Addendum No.1
to
CONSTRUCTION DOCUMENTS
for

May 21, 2025
2023159.00

NCISD New District Administration Building
21330 Valley Ranch Parkway
New Caney, TX. 77357
May 20, 2025

SKETCH REFERENCED FROM SHEET AS-004

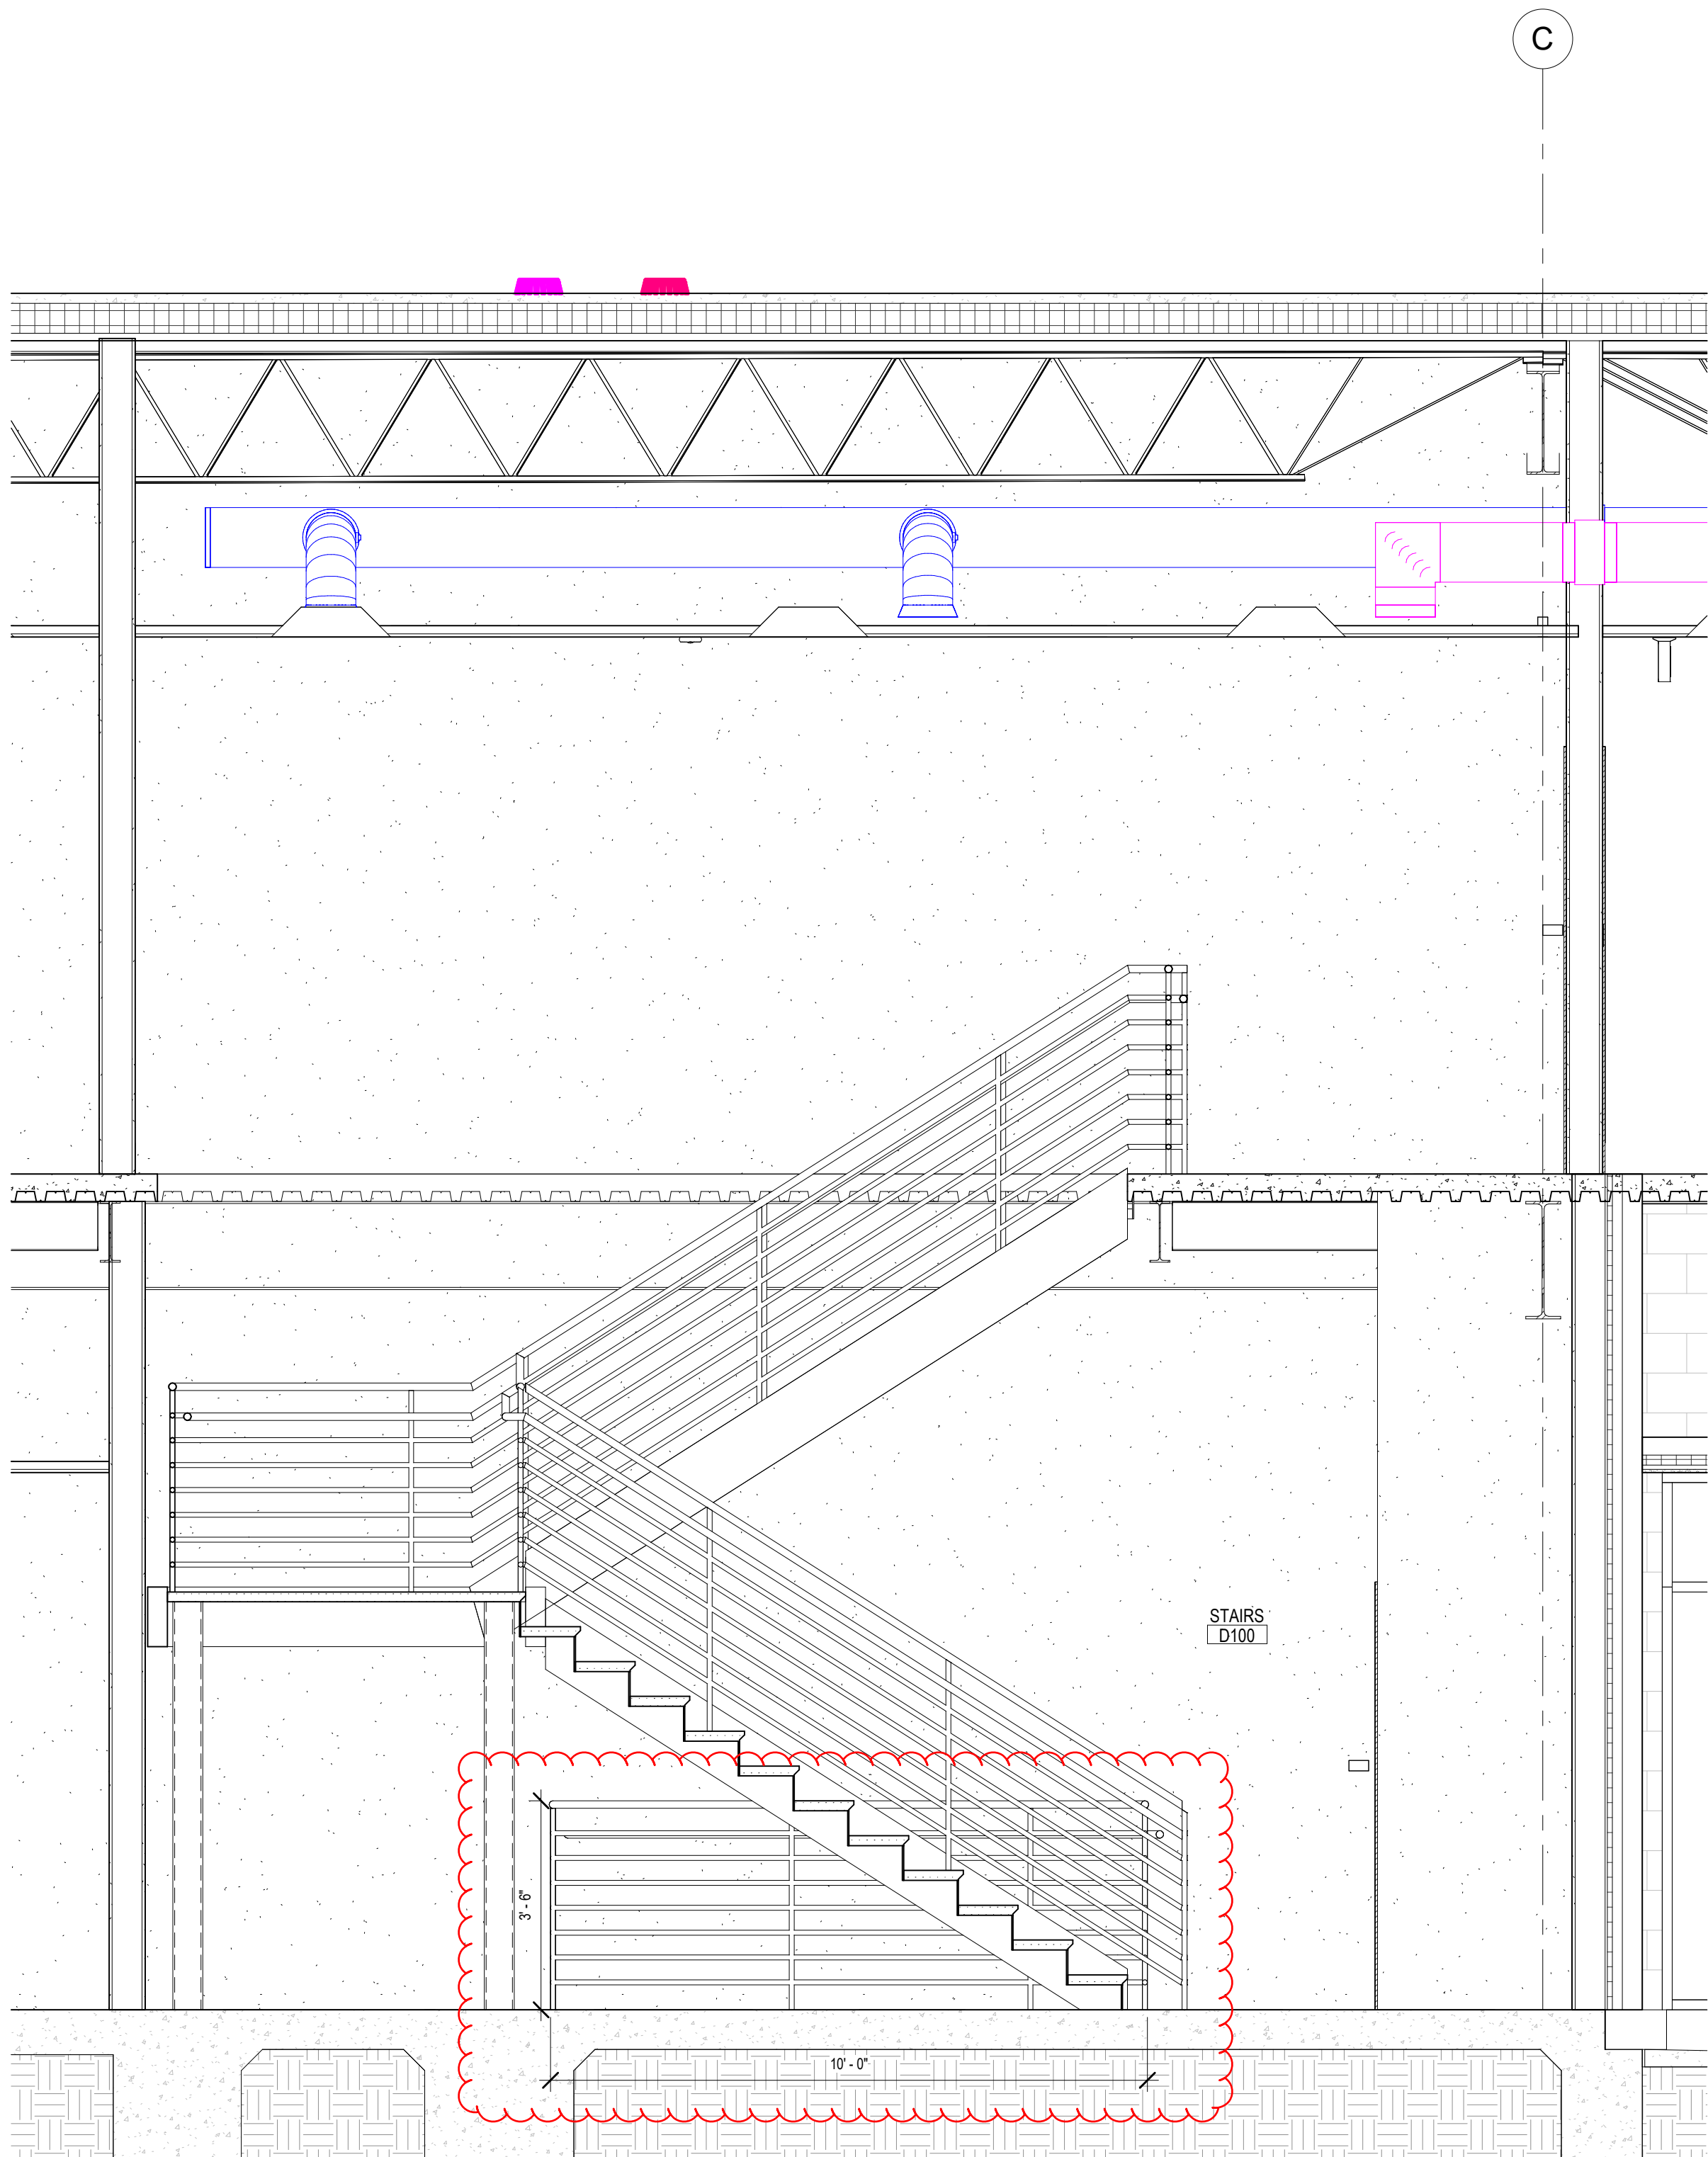
2. Sheet AS-004 – Site details
 - a. Added B5 detail to sheet. Refer to Sketch 16.
3. Sheet AS-009 – Enlarged Site Plan and Details
 - a. Added new sheet in its entirety.

SKETCH REFERENCED FROM SHEET A-316

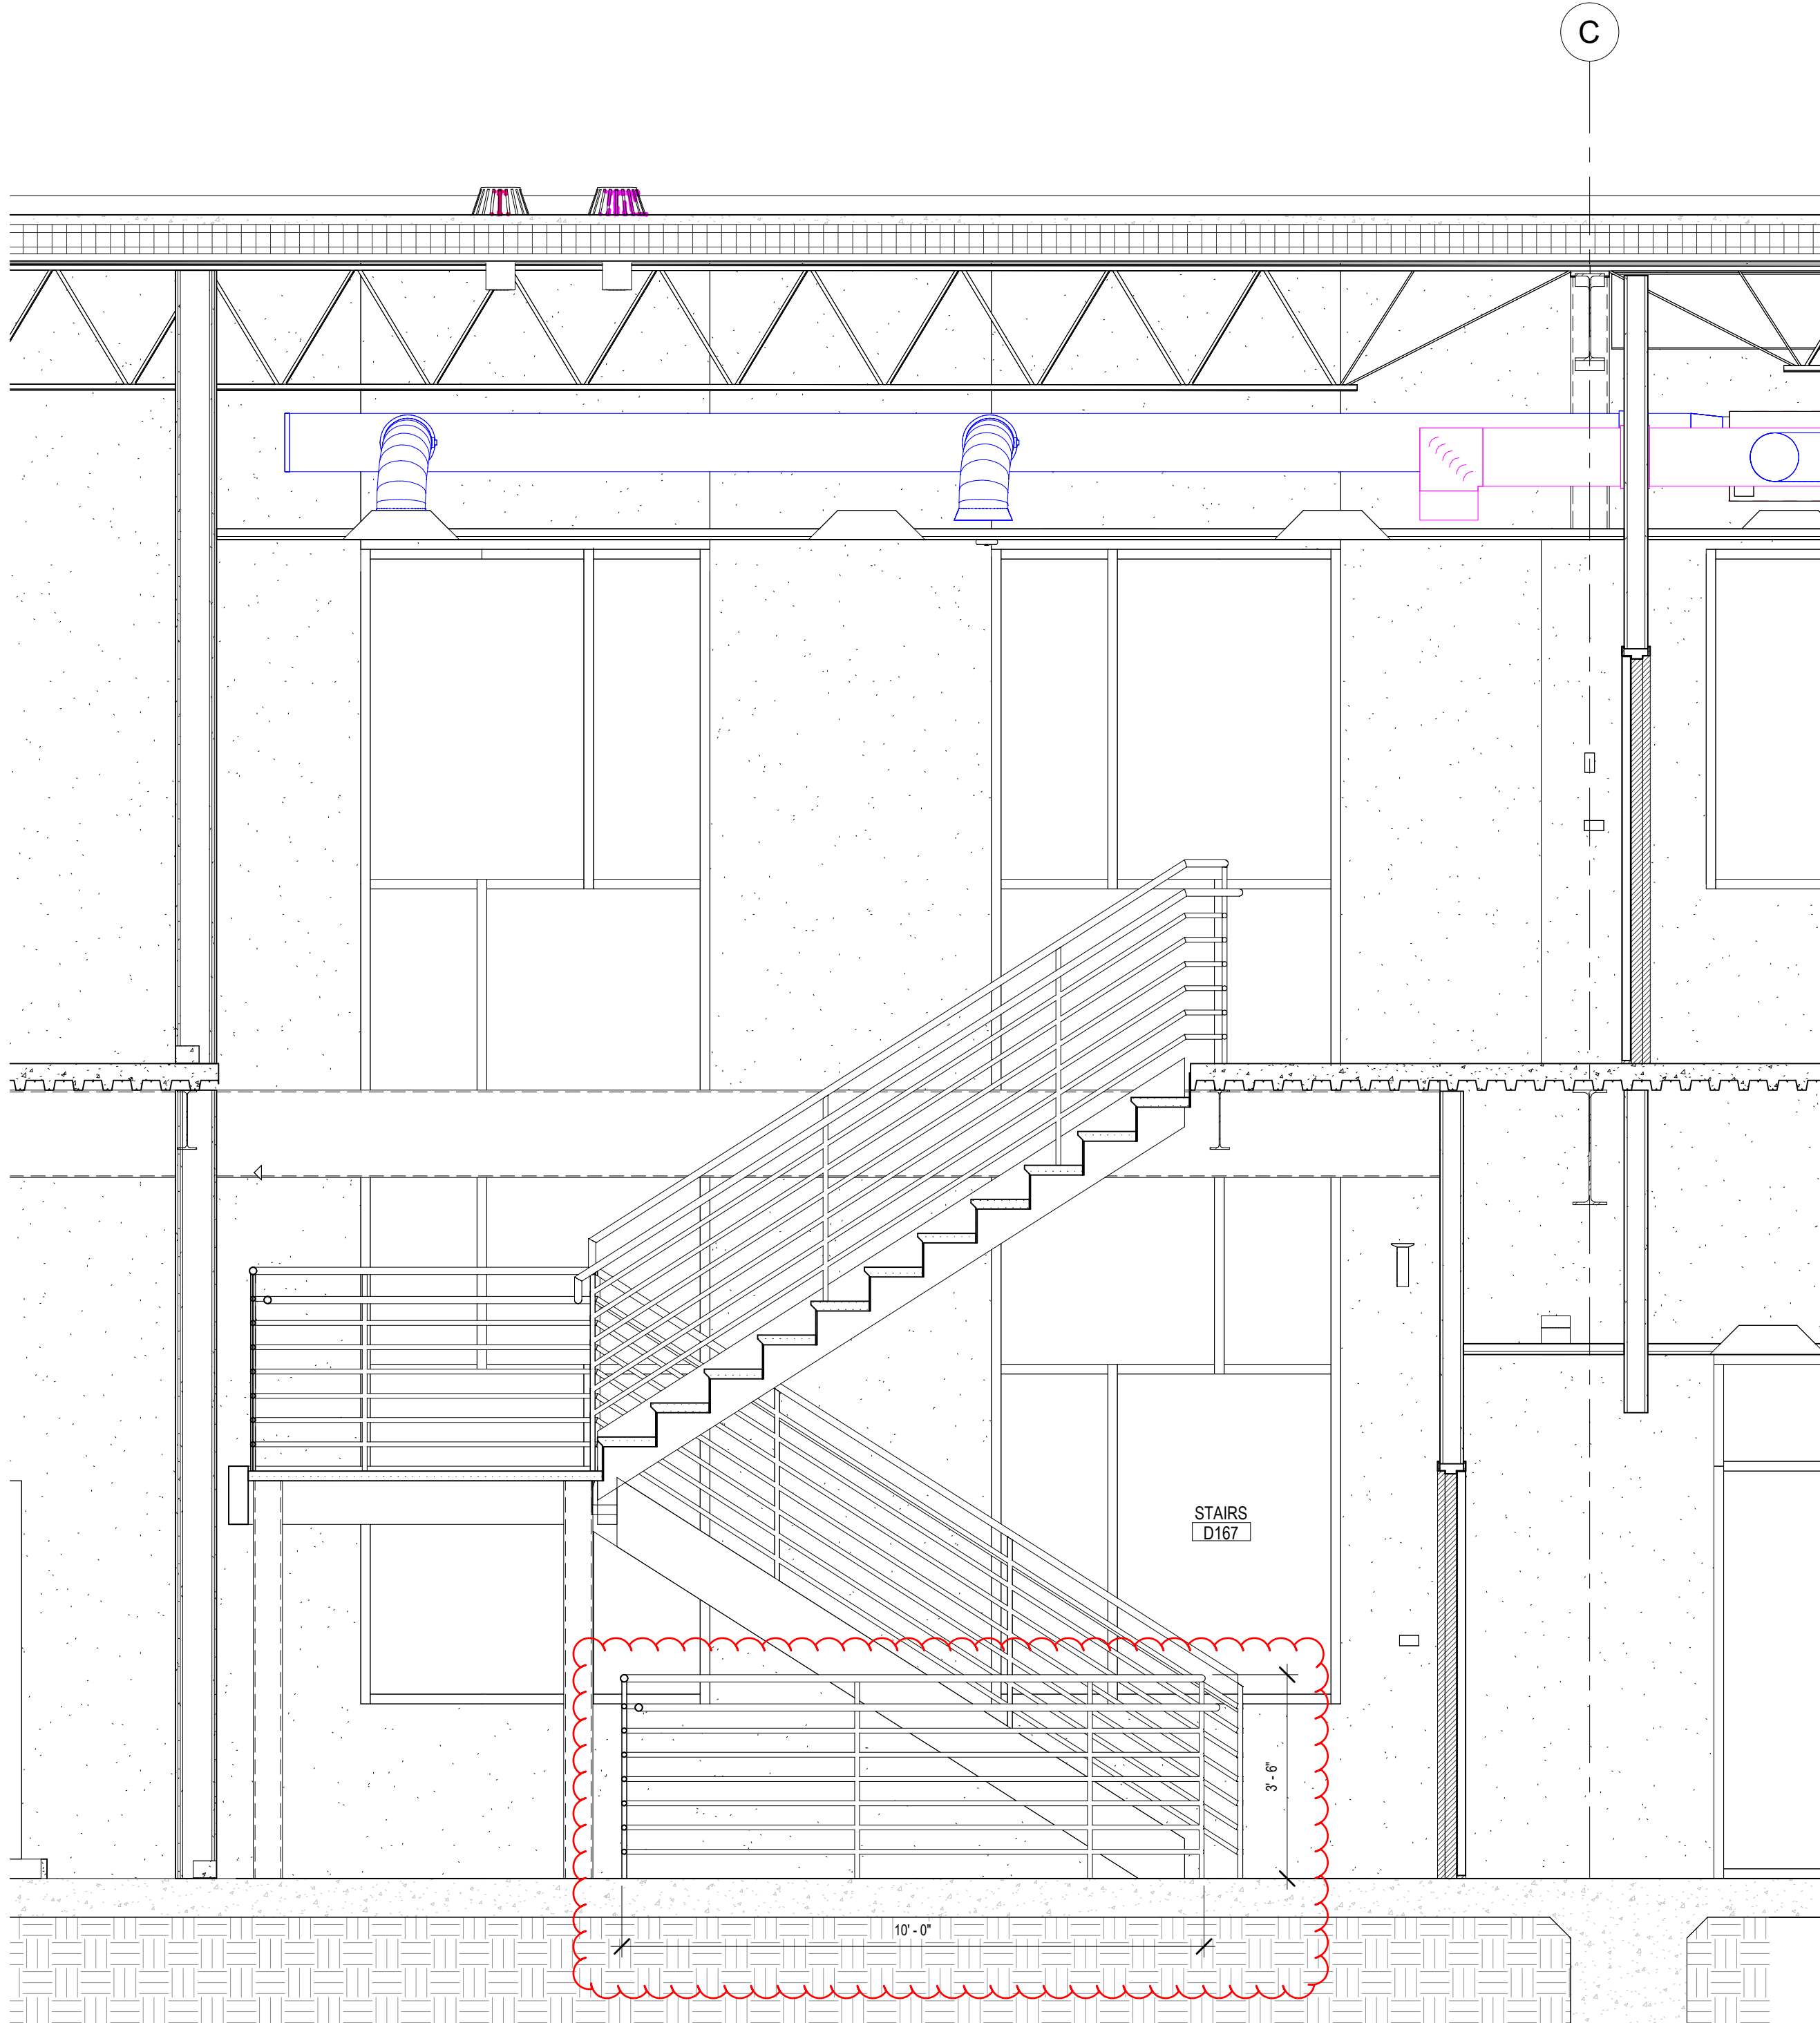
9. Sheets A-316 and A-319 – Wall Sections
 - a. Detail A3
 - i) Added cane detection railing and dimensions beneath stairs as shown in Sketch 17.
10. Sheet A-401 – Enlarged Plans and Typical Mounting Heights

A1 ENLARGED FIRST FLOOR PLAN - STAIR D100
1/4" = 1'-0"

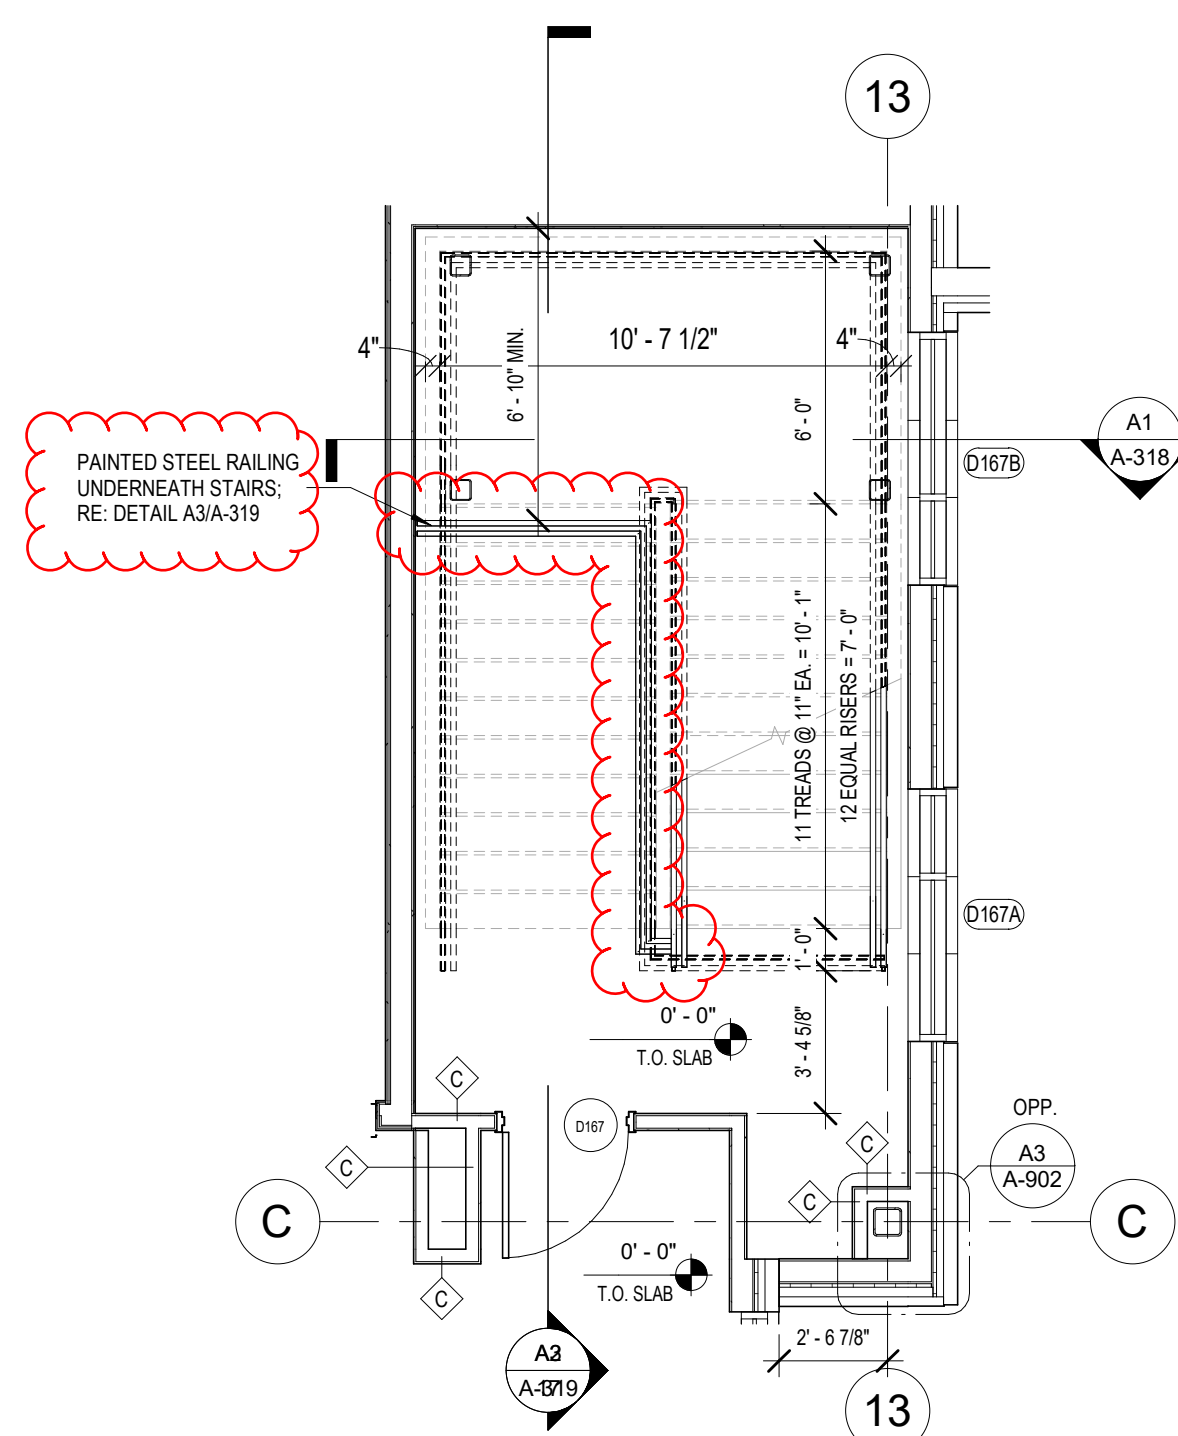
11. Sheet A-402 – Enlarged Plans – Restrooms
 - a. Added details E2 and E3 to sheet as shown in Sketch 18
12. Sheet A-403 – Enlarged Plans – Stairs
 - a. Detail A1 & A2

- i) Updated to show railing beneath stairs as shown in Sketch 19.
 - ii) Added note “PAINTED STEEL GRADE TYPE AISI 304/304L OR 316/316L; RE: SPECS” as shown in Sketch 19.
